Contract Name Sign Shop HVAC Modifications -
Traffic Engineering Building -
Sayle Street

Change Order Description Electrical Wiring

Date	
Change Order Number	CO 3
To Public Works Contract Number	6039
Original Contract Project Number	0
Change Order Project Number	0

Change Order Description Increase height of ice deflection
structure over HVAC condensing
unit.

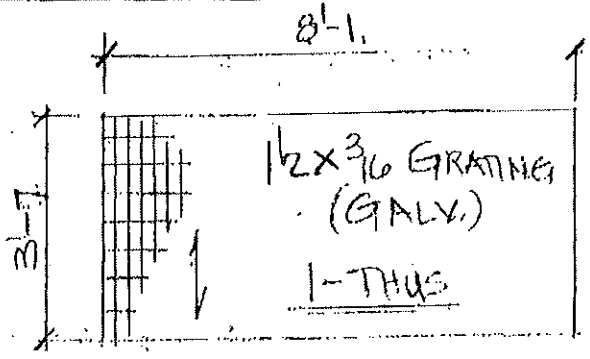
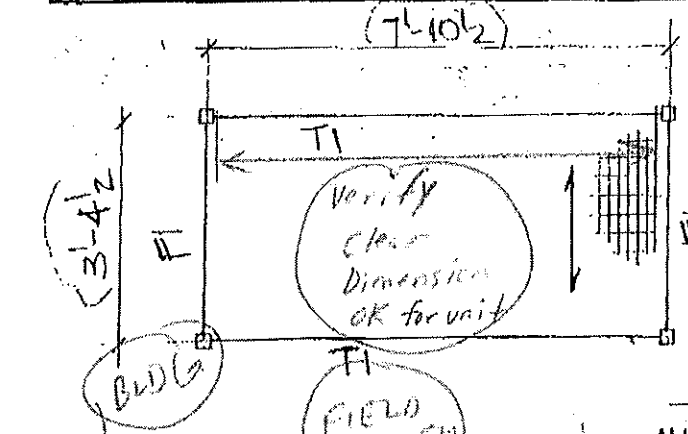
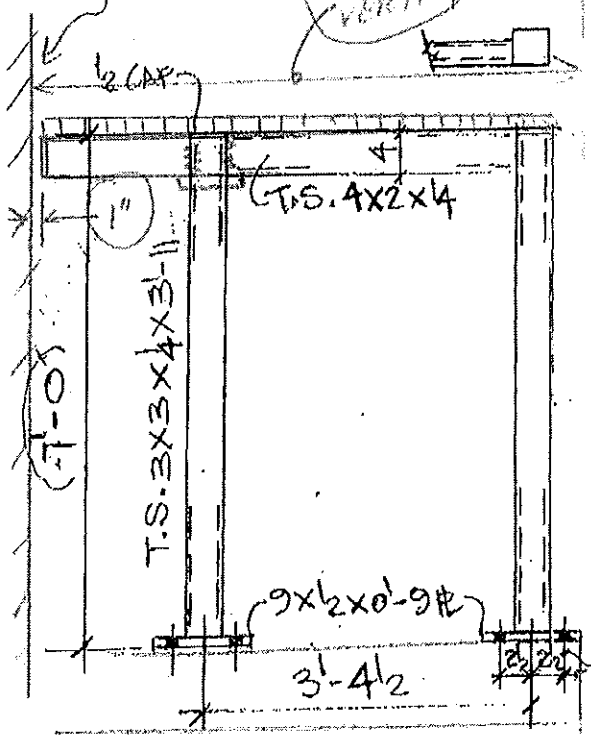
Proposal to furnish and install alternative ice deflection structure as follows per marked up submittal:

1. Revise shop drawings for fabrication.
2. Due to the need for the condensing unit to have 36" of clear air space between it and the building, the ice structure needs to cantilever back toward the building almost 3' to prevent ice from falling between the building wall and the condenser. The two columns closest to the building need to be cut down and plates added to the top of them, then the tube frame will extend across them and cantilever back toward the building (hence longer framework). The galvanized bar grating shall extend back toward the building as well, covering the framework.
3. Work includes additional labor and materials for fabrication, finishing, and erection.

Item No.	Description	Est. Qty	Unit	Unit Price	Total Add	Total Deduct
1	Change height of ice deflection structure above condensing unit.	1	ea	879.00	879.00	0.00
					0.00	0.00
					0.00	0.00
					0.00	0.00
					0.00	0.00
					0.00	0.00
					0.00	0.00
					0.00	0.00
					879.00	0.00
